**Our Case Number:** ABP-314610-22

**Re:** BusConnects Ballymun/Finglas to City Centre Core Bus Corridor Scheme  
Ballymun/Finglas to Dublin City Centre

**RE: Ballymun/ Finglas to City Center Core Bus Corridor**

**An Bord Pleanála Case No. 314610**

Figure 6 Greater Dublin Area Cycle Network Route C8 Unaccounted for in Proposal

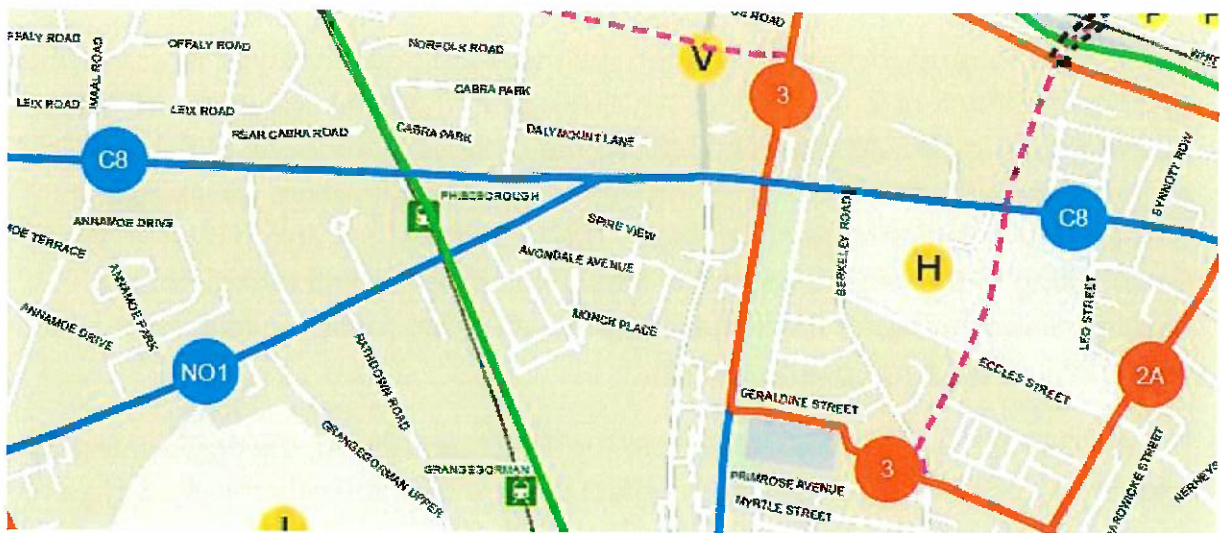
It is deeply concerning that Chapter 04 of the application "Proposed Scheme Description" Section 4.6.6 Integration fails to mention the "Greater Dublin Area Cycle Network Plan (GDACNP) (NTA 2013)." This Bus Connects project is a project that is marketed as a cycle infrastructure project: the designers must integrate the GDACN into their proposals.

Furthermore There is no east-west connection for cyclists in Phibsboro, disregarding the future cycling facility of C8 Route of Greater Dublin Area Cycle Network on the North Circular Road (NCR). Instead there are three vehicle lanes proposed on the NCR.

Figure 9 ImageJ analysis showing 1.45m width for Section 5 Finglas.

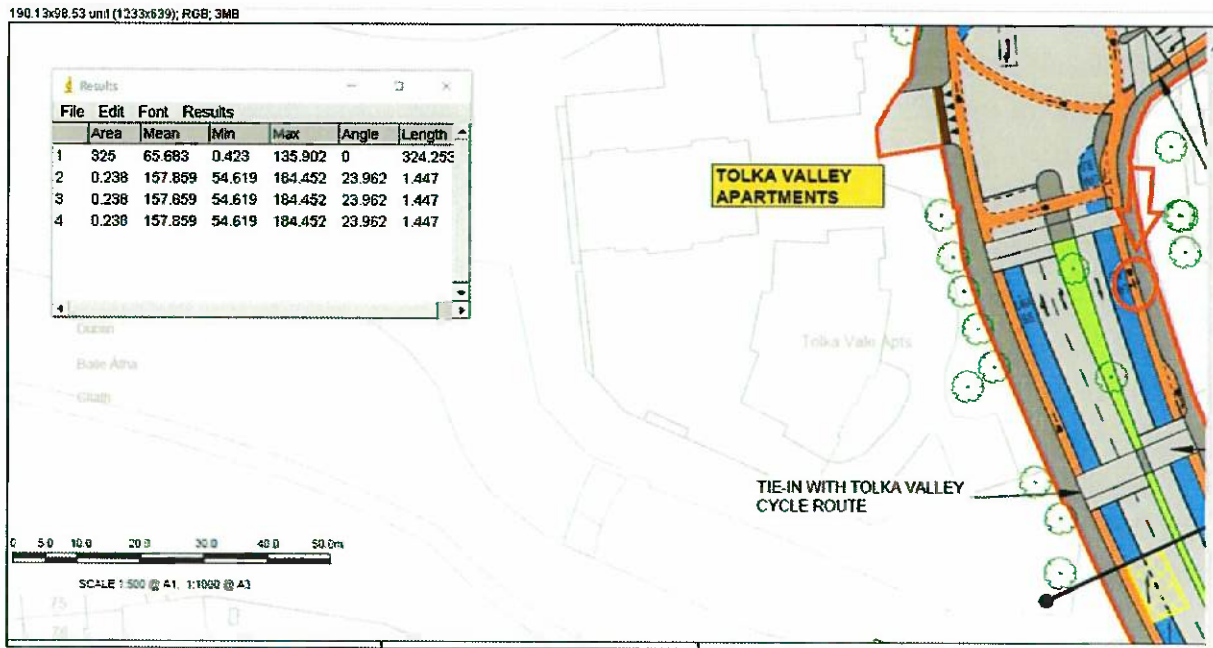
The proposed widths of cycling infrastructure throughout the scheme are simply not fit for purpose. Section 2.3 of the Written Report of Greater Dublin Area Cycle Network Plan, outlines the desired width of primary cycle routes as 2.5m - see table below.

For example, the 1.45m (Figure 9) cycle track proposed in Section 5 (see specific comments below) is unacceptable on a road that has up to five lanes and a central median (see image).
